PROJECT NUMBER _____ PROJECT NAME AND CRC C&D

RE: Proposed Anderson Creek C&D Landfill
Harnett County; Permit #43-03

RE: Monitoring Well Installation - Closed Out Cells
Anderson Creek Construction and Demolition Landfill
Harnett County, North Carolina

RE: Site Suitability and Construction Plan Applications
Proposed C&D Landfill Unit
Anderson Creek Landfill; Permit #43-03

FIGURE I

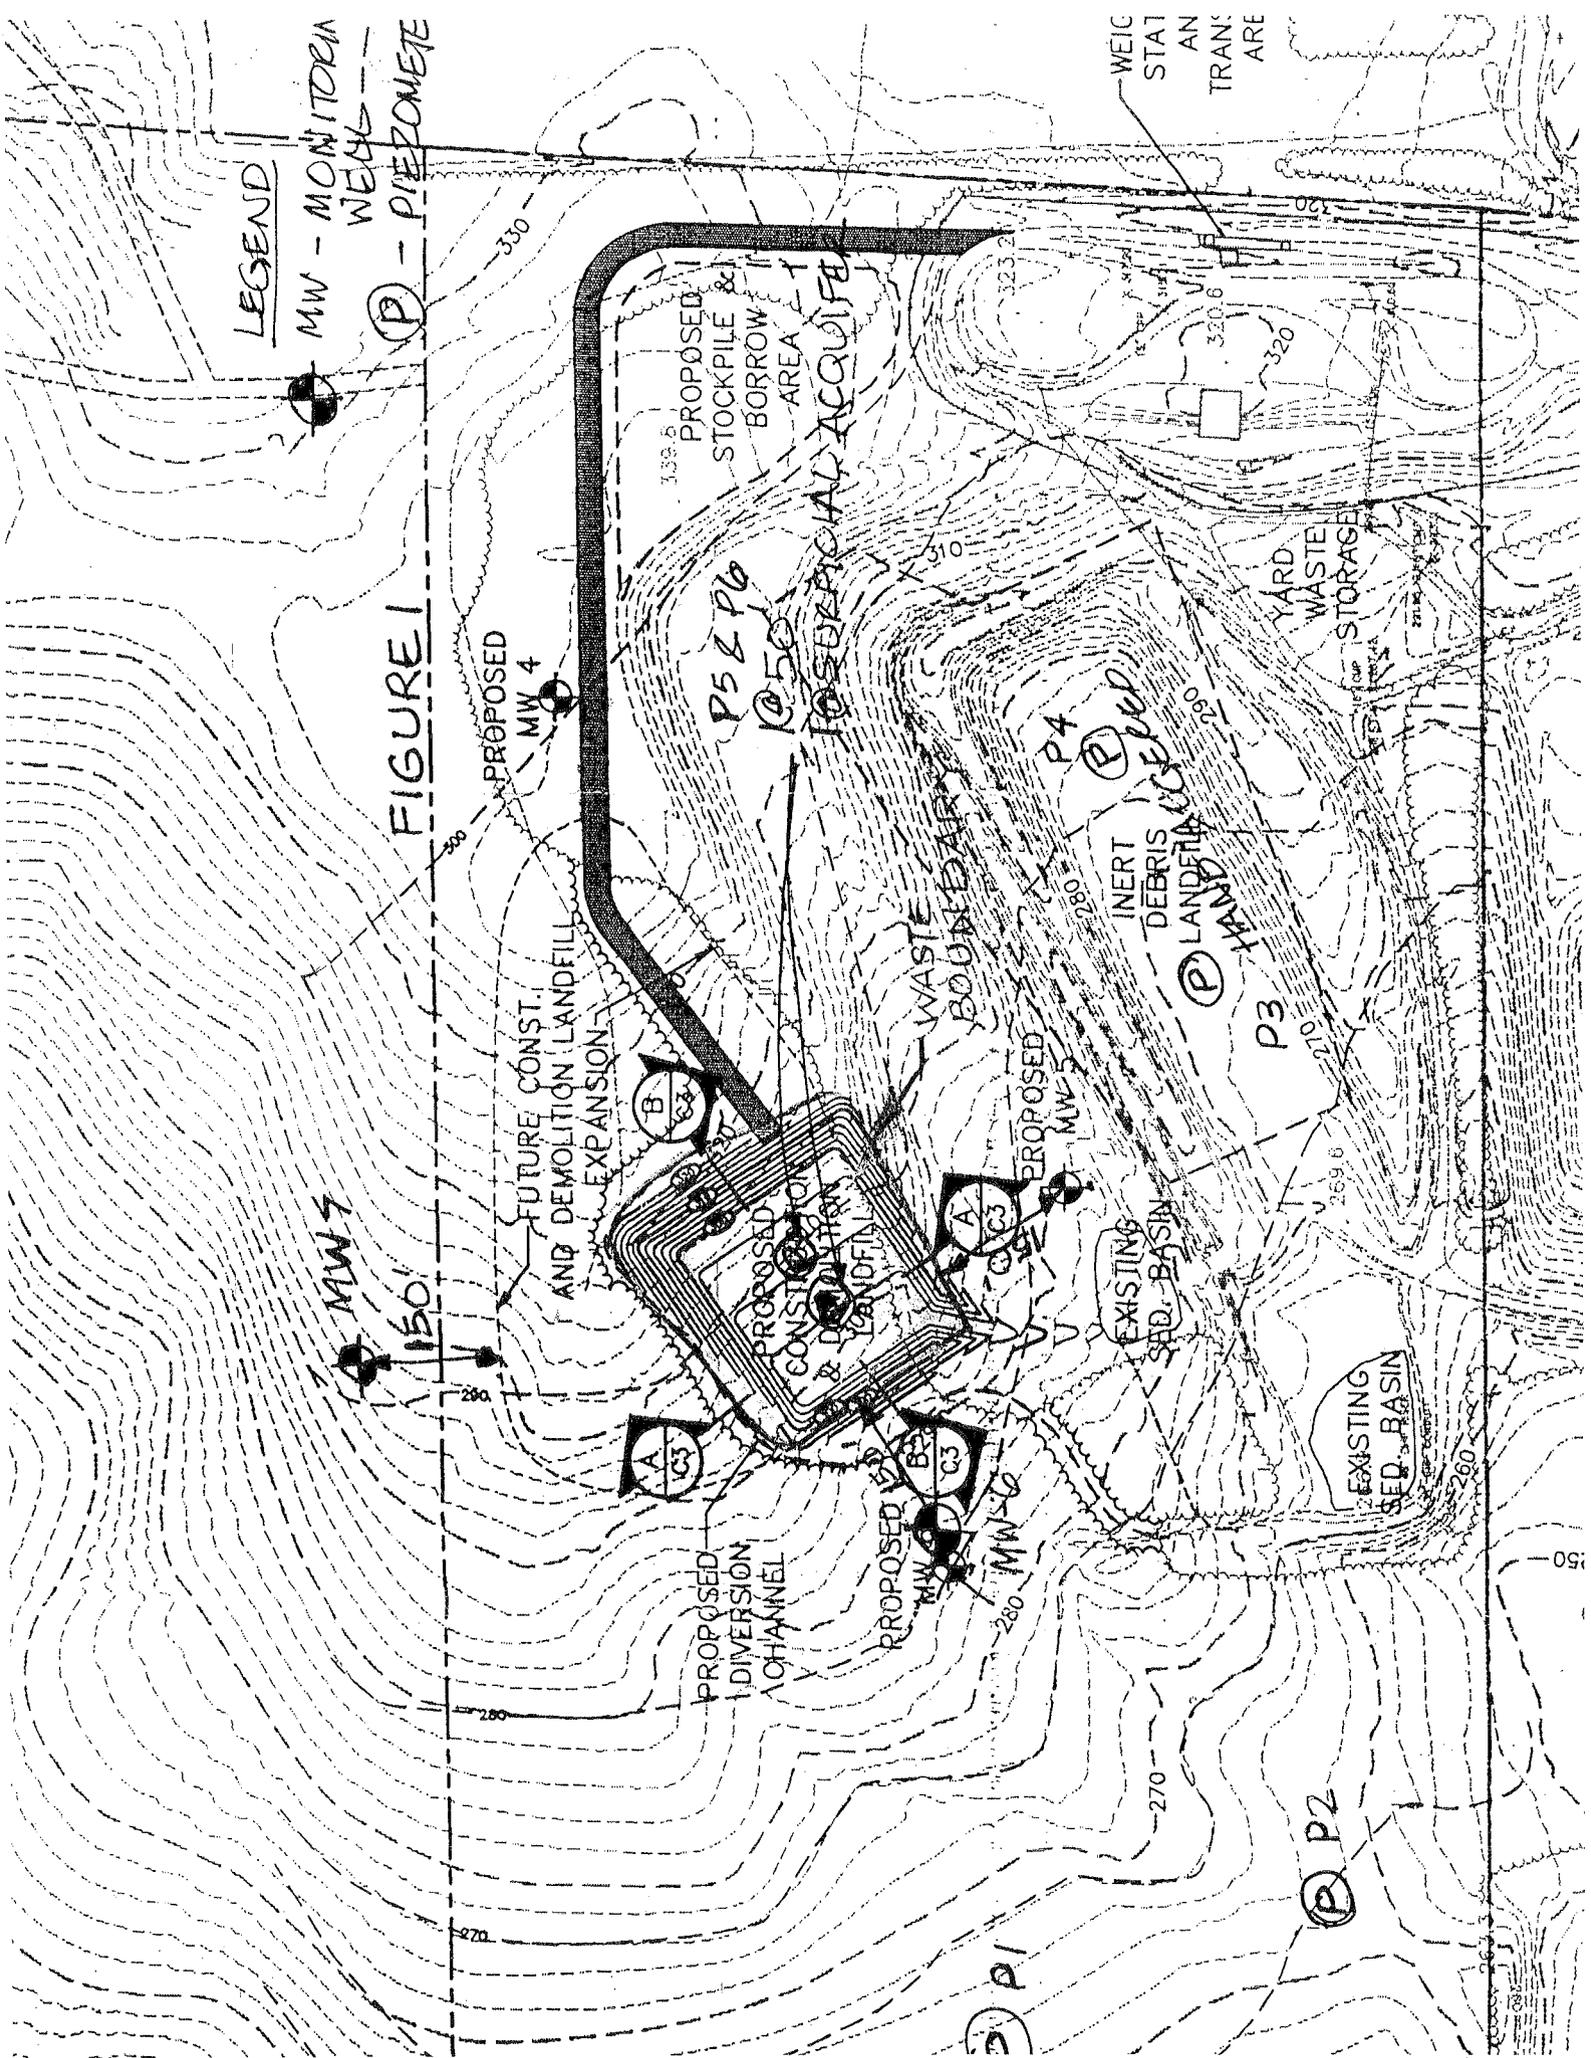
This letter is a follow-up to our meeting of December 19, 1995 and your letters of December 8 and 28, 1995. Enclosed please find Figure 1. Figure 1 is taken from Sheet C3 of the Site Suitability Application for the Anderson Creek Construction and Demolition (C&D) Landfill in Harnett County. The proposed monitoring wells and piezometers are located on Figure 1 based on our understanding from our December 19, 1995 meeting.

Please review Figure 1 and get back to me with any comment you may have. Your assistance in this matter is greatly appreciated. Thanks again for your time.

I have reviewed the proposal from McKim and Creed Engineers, P.A., dated January 3rd, 1996, for additional subsurface investigation at the Anderson Creek landfill. The four Type II wells, four piezometers, and two hand auger piezometers proposed in the letter meet the needs for further information to site and design the proposed C&D unit, as discussed during our December 19, 1995 meeting.

At this stage of the application process, the Solid Waste Section cannot grant final approval for a proposed water quality monitoring system for the unit. However, if exploratory borings are installed with the intent that they could serve as permanent monitoring wells, their installation must meet the following conditions:
